In Reply Refer To:  
HSST/SS-115A

Name of system:	U-Bracket Sign Support
Type of system:	Breakaway Small Sign Support
Test Level:	NCHRP Report 350 TL-3
Testing conducted by:	N/A
Date of request:	5/15/2013

# Engineering Analysis for Galvanizing Drain Hole Enlargement on U-Bracket Sign Support

Existing Part

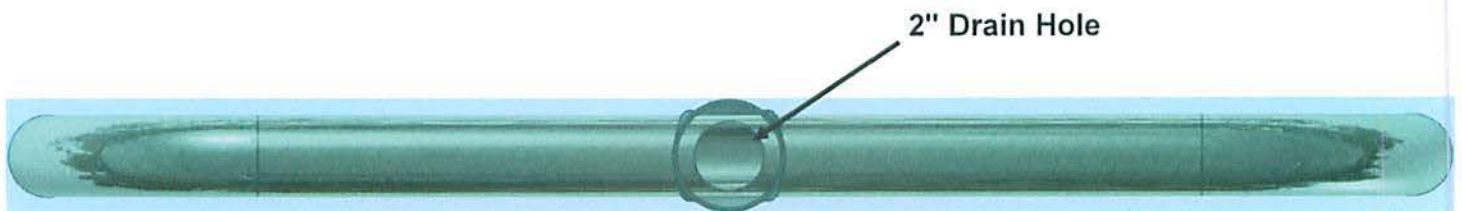
Hot-dip galvanizing the U-Bracket in its present design poses a challenge because the single drain hole is not large enough for the air in the tubes to escape, which causes the U-Bracket to float in the galvanizing tank.

Increasing the drain hole diameter to 2 inches from the current 1/2 inch will allow the U-Bracket part to be fully submersible in the hot dip galvanizing tank so that it does not float on the surface of the molten zinc bath. An engineering analysis was performed on the part and it showed that increasing the drain hole to 2 inches has no effect on the structural integrity, function and performance of the part.

**Figure 2 - Result for 1/2" Diameter Drain Hole, Bottom View.**

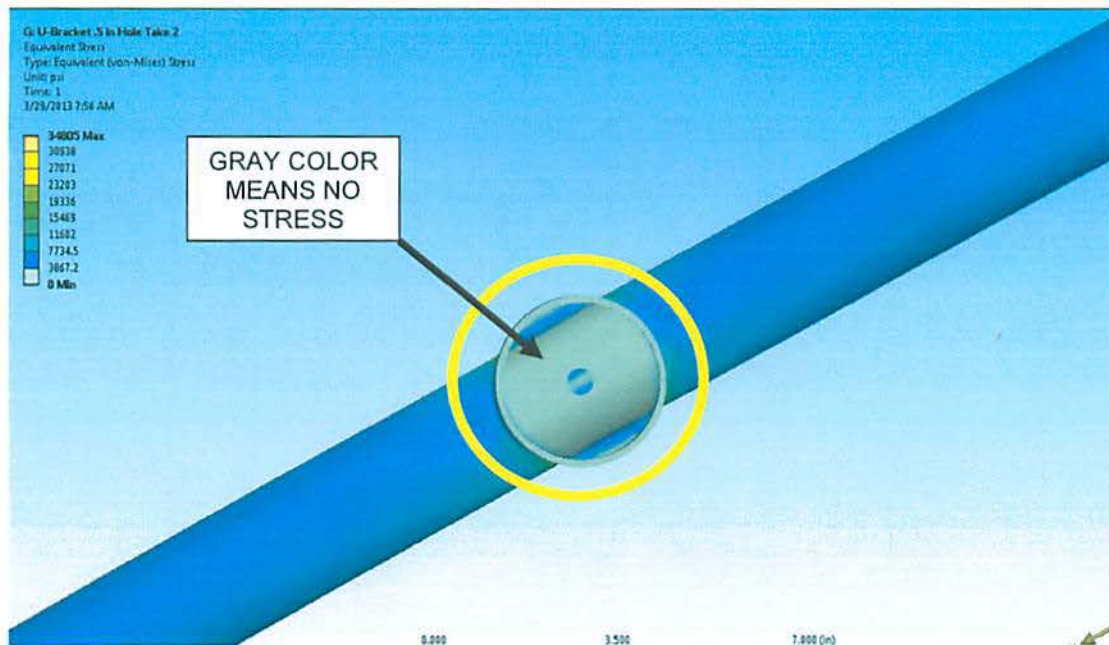
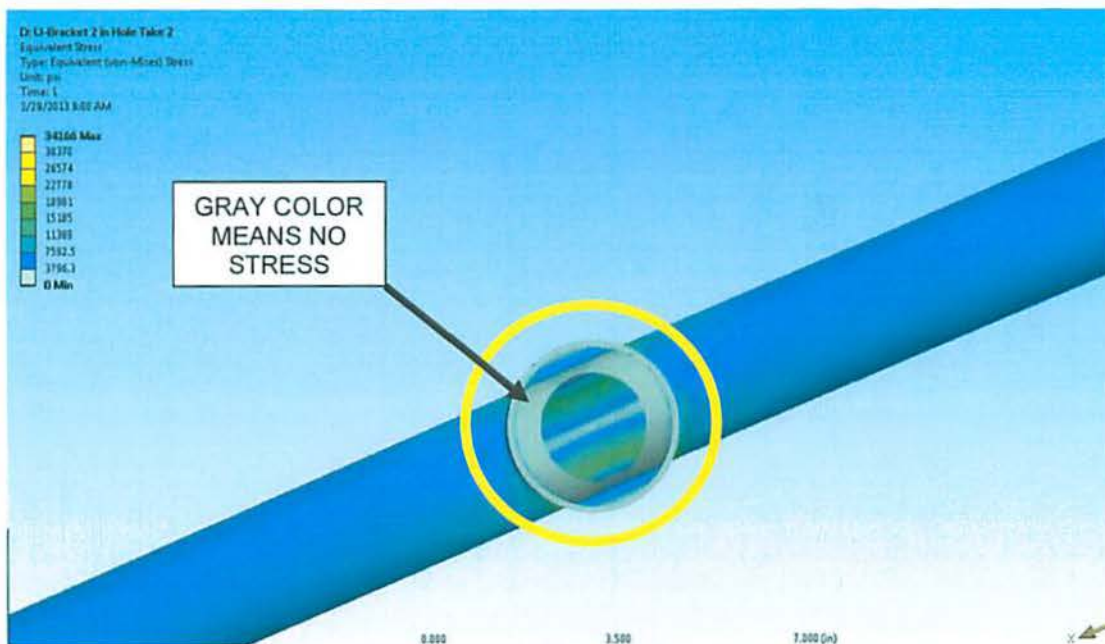
The increased drain hole size did not have a significant effect on the structural integrity, function or performance of the U-Bracket. As illustrated in Figures 2 and 4 the stress level near the hole inside the mounting nipple remained effectively the same. This is because the material within the mounting nipple is isolated from the rest of the structure by the weld that secures the mounting nipple to the U-Bracket tube. The location of the maximum stress is found at the corners of the welded portion of the mounting nipple where it joins the U-Bracket tube, as seen in color red in Figures 3 and 5.

The engineering analysis showed that the increased drain hole diameter does not affect the structural integrity, function and performance of the U-Bracket.
